Coffs Harbour Highway Planning

Sapphire to Woolgoolga section

ENVIRONMENTAL ASSESSMENT SUBMISSIONS REPORT

JULY 2008

FIGURE 4.1A PROPOSED CHANGE TO PROPERTY ACQUISITION AREA

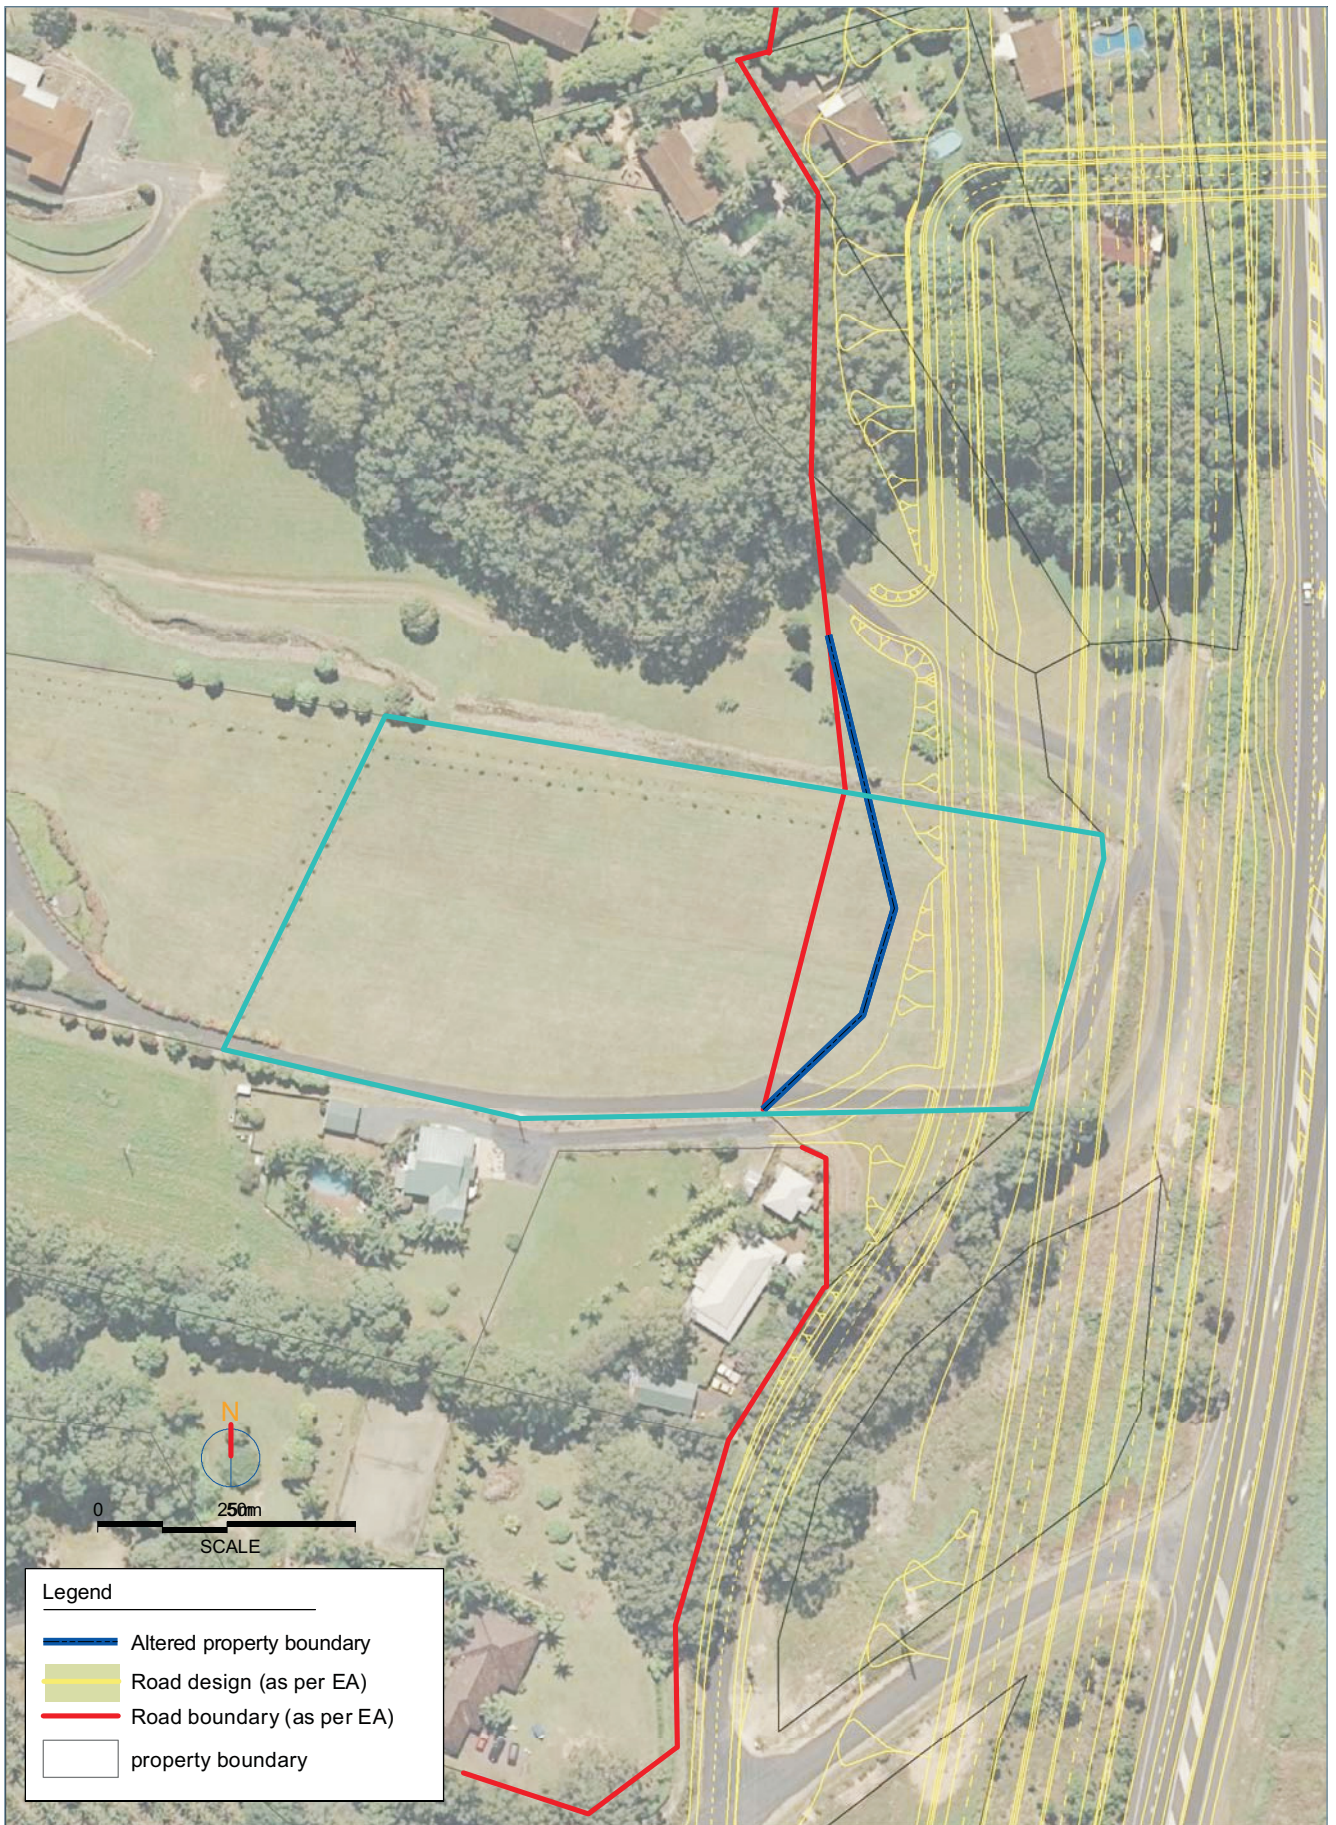
- Respondent strongly objects to the compulsory acquisition of their property. The design shows the proposed new road reserve boundary in close proximity to the respondent's front door and there are plans to take land at the back of the property which will cut the access between the respondent's property and the adjacent property which belongs to a relative.

The Proposal design at this location has been reviewed and revised. It is proposed to shift the boundary to the east, closer to the existing property boundary. This would reduce the area of acquisition for this property by approximately 770m².

- Property Effect No. 16; located in Hunter Close (refer Figure 4.1a): It is proposed to shift the boundary to the east, closer to the existing property boundary, reducing the required area of acquisition by approximately 770m².
- Property Effect No.113 located at Newmans Road (refer Figure 4.1b): It is proposed that the road reserve boundary at this location be refined reducing the required area of acquisition by approximately 0.37 ha.
- Property Effect No.125; located in Bark Hut Road (refer Figure 4.1c): It is proposed that the road reserve boundary at this location be refined reducing the required area of acquisition by approximately 0.46 ha.
